MIDLAND PROJECT
INFORMATION REQUEST - SEISMIC CATEGORY I MASONRY WALLS
FILE: B3.8 UFI: 42*05 SERIAL: 9406

MIDLAND PLANT UNITS 1 AND 2

RESPONSE TO REQUEST FOR INFORMATION ON THE USE
OF SEISMIC CATEGORY I MASONRY WALLS

FIGURE 1

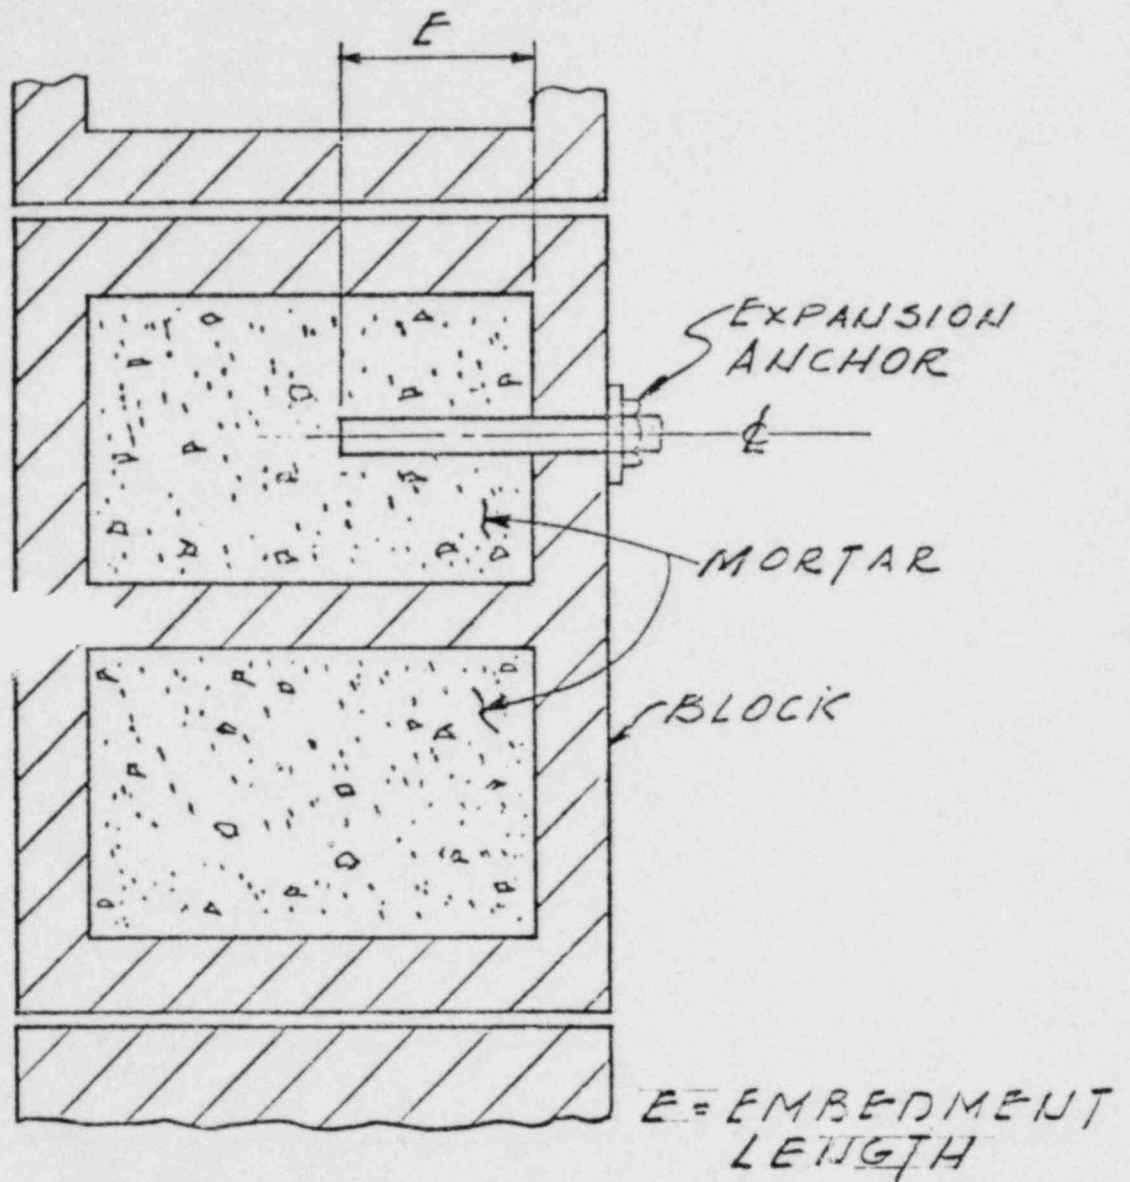
How were the masonry walls and the piping/equipment supports attached to them designed? Provide enough numerical examples including details of reinforcement and attachments to illustrate the methods and procedures used to analyze and design the walls and the anchors needed for supporting piping/equipment (as applicable).

Items supported by Seismic Category I masonry walls are limited to small piping, 2-1/2 inches and smaller in diameter, and lightweight equipment. They are attached by expansion anchors, grouted anchors, or through bolts. Below is the design information for typical attachments to the blockwalls.

Expansion ⁽¹⁾ Anchors	Grouted ^(1,3) Anchors	Through ^(1,3) Bolts
Detail	Figures 1, 2	Figures 1, 2	Figure 3
Tension capacity ⁽²⁾	600 lb ⁽²⁾ (total loads)	1,600 lb	2,500 lb
Shear capacity ⁽²⁾		3,000 lb	2,500 lb
